# Access Compliance Report

## Public Rights-of-Way

### (Curb Ramps)

Intersection ID: 49933	Main Street: MARVIN_RD	Cross Street: WOBURN_RD	Location: SE
ADA ID: AFB08D977392	Ramp Type: Perp	Initial Pass/Fail: Fail	Overall Compliance: No
		Severity Score: 12.5

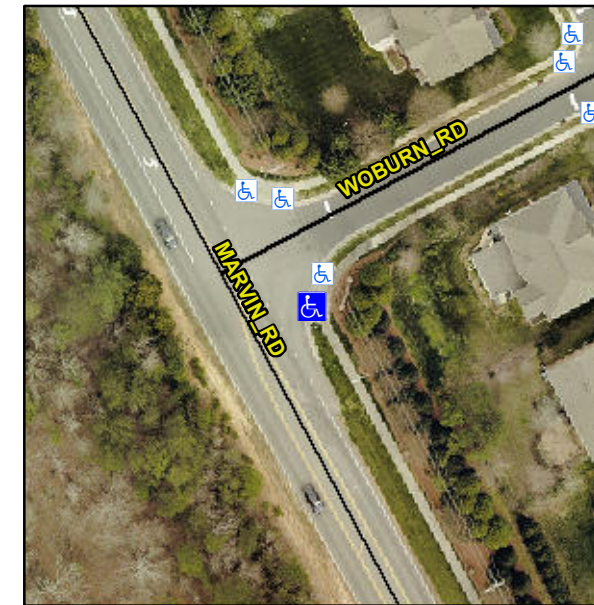
**Not Found, R304.2.2**

Compliance	Description	Data	Compliance	Description	Data
N/A	Ramp Length (in)	59.0	No	Ramp Slope (%)	8.9
Yes	Ramp Width (in)	48.0	Yes	Ramp XSlope (%)	0.8
N/A	Flare Type LT	N/A	N/A	Flare Type RT	N/A
N/A	Flare Slope LT (%)	N/A	N/A	Flare Slope RT (%)	N/A
N/A	Flare Traversable LT?	N/A	N/A	Flare Traversable RT?	N/A
N/A	Landing Length (in)	N/A	N/A	DWS Provided?	N/A
N/A	Landing Width (in)	N/A	N/A	DWS Contrast?	N/A
N/A	Landing Slope (%)	N/A	N/A	DWS Length (in)	N/A
N/A	Landing X Slope (%)	N/A	N/A	DWS Full Width?	N/A
N/A	Landing Curb? (Y/N)	N/A	N/A	DWS Offset (in)	N/A
N/A	Shared Landing?	N/A			
N/A	Gutter Ponding?	N/A	N/A	Gutter Slope (%)	N/A
N/A	Gutter Lip Ht (in)	N/A	N/A	Gutter X Slope (%)	N/A
N/A	Painted X Walk1?	No	N/A	Painted X Walk2?	N/A
	X Walk 1 Direction	To W		X Walk 2 Direction	N/A
N/A	X Walk 1 Width (in)	N/A	N/A	X Walk 2 Width (in)	N/A
	X Walk 1 Slope (%)	0.2		X Walk 2 Slope (%)	N/A
	X Walk 1 X Slope (%)	9.6		X Walk 2 X Slope (%)	N/A

**Remove & Replace Entire Ramp.**
